## LANDMARK COMMISSION

FILE NUMBER: COA-26-000207  
LOCATION: 4315 Junius St  
STRUCTURE: Noncontributing  
COUNCIL DISTRICT: 2

A Certificate of Appropriateness to revise previously-approved plans on COA-25-000313 by modifying the height of the foundation on the main structure.

**A5.02**

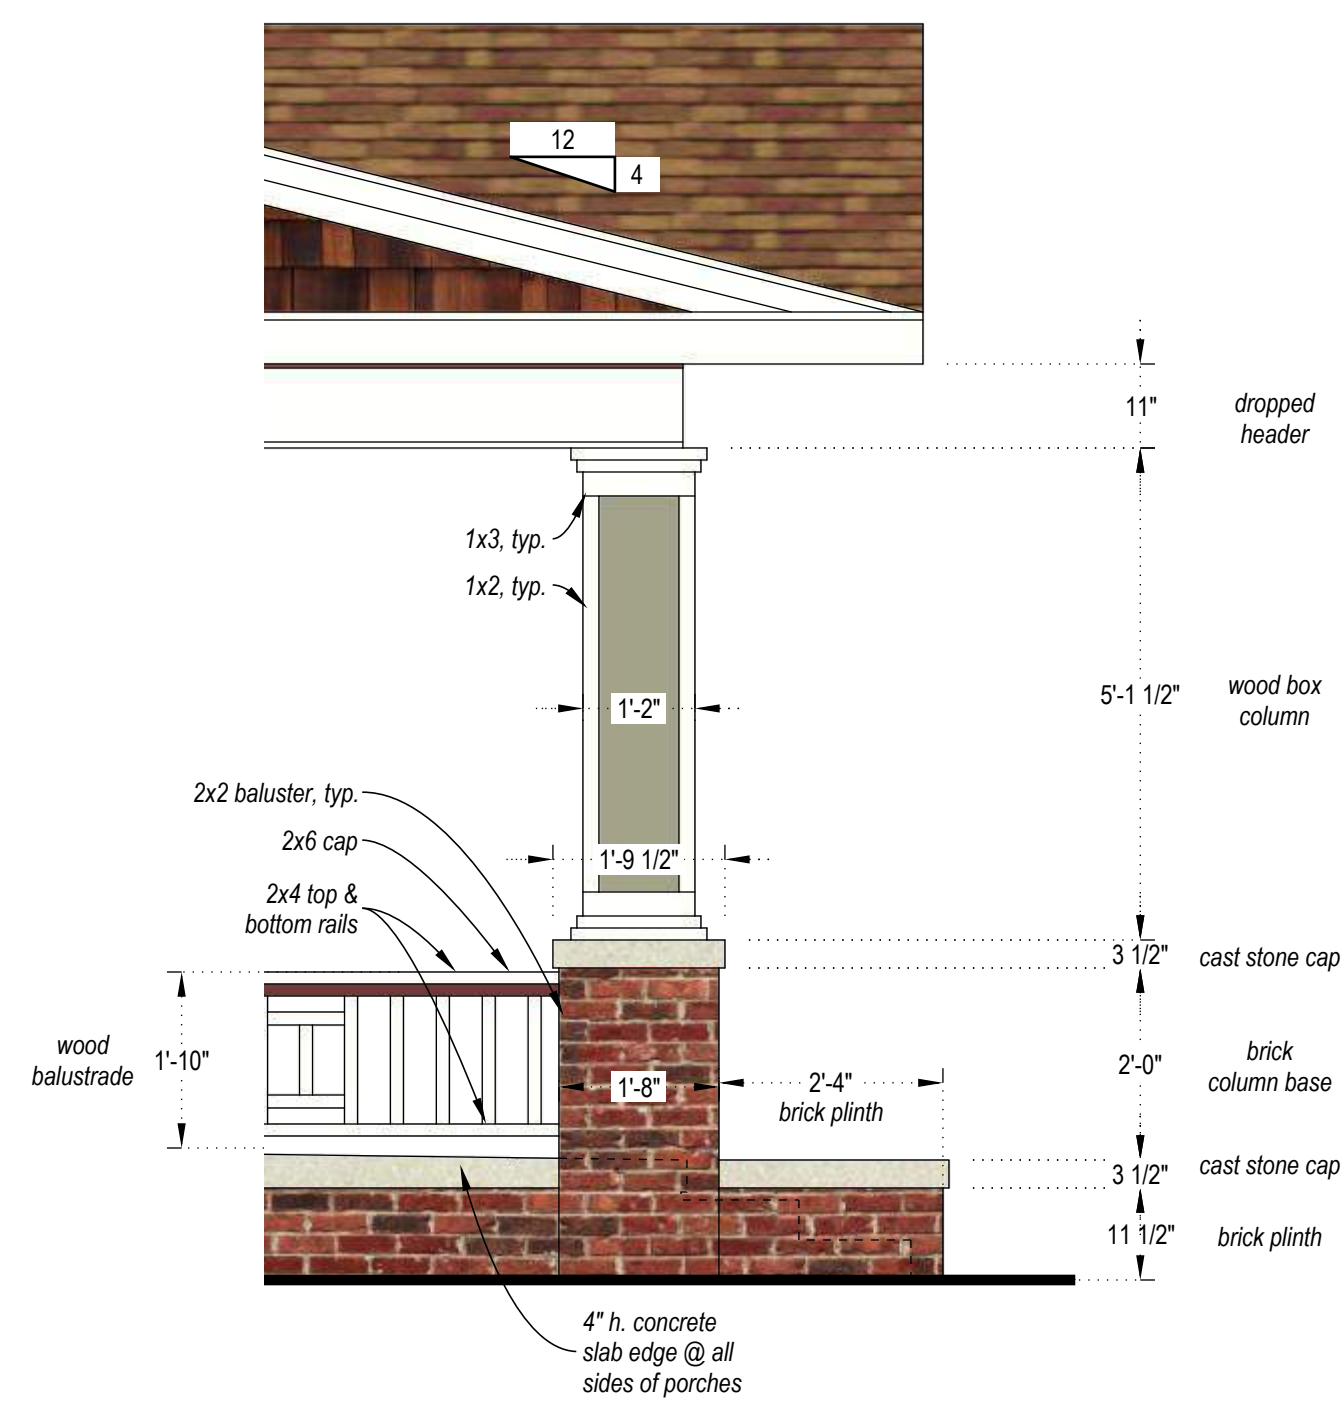
That the request to revise previously-approved plans on COA-25-000313 by modifying the height of the foundation on the main structure be **approved** in accordance with drawings and specifications dated 6/1/2026 with the finding of fact that proposed foundation height is consistent with the neighboring main structures and would not have an adverse effect on the district. The proposed work is, therefore, consistent with preservation criteria Section 4; meets the standards in City Code Section 51-4.501(g)(6)(C)(ii) for **noncontributing** structures; and the Secretary of the Interior's Standards for Rehabilitation.

That the request to revise previously approved foundation height on the main structure be approved as submitted.

6" foundation height at rear

27" foundation height at front
